PROJECT NAME: BETHEL-RANDOLPH	PLOT DATE: 4/23/2015
PROJECT NUMBER: STP 292(I)	DRAWN BY: S. LAMPHERE
FILE NAME: z10c244bdr.dgn	CHECKED BY: C. LATHROP
PROJECT LEADER: C. LATHROP	SHEET 37 OF 211
DESIGNED BY: S. LAMPHERE	
PLAN SHEET II

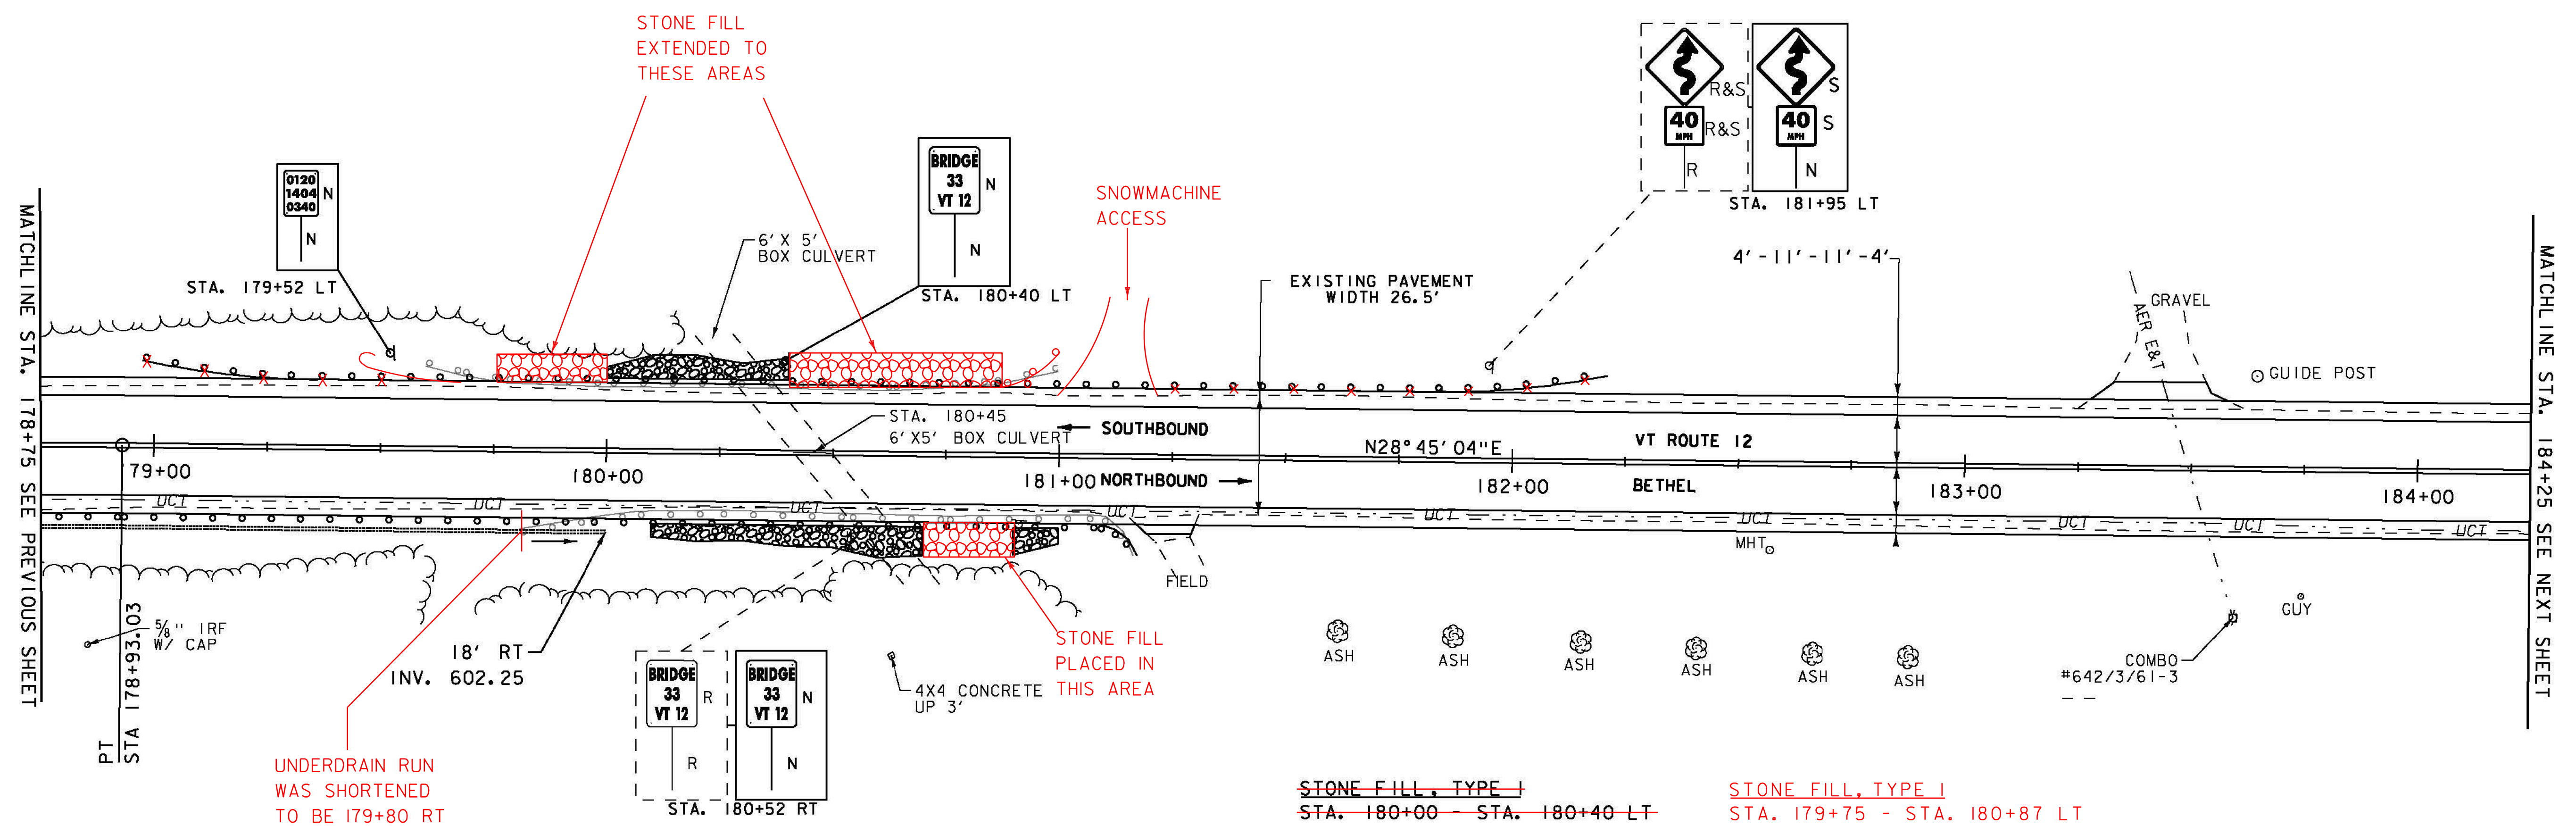
UNDERDRAIN RUN WAS SHORTENED TO BE 179+80 RT

STONE FILL PLACED IN THIS AREA

~~STONE FILL, TYPE I~~
~~STA. 180+00 - STA. 180+40 LT~~
~~STA. 180+10 - STA. 180+70 RT~~
~~STA. 180+90 - STA. 181+00 RT~~

STONE FILL, TYPE I
 STA. 179+75 - STA. 180+87 LT
 STA. 180+10 - STA. 181+00 RT
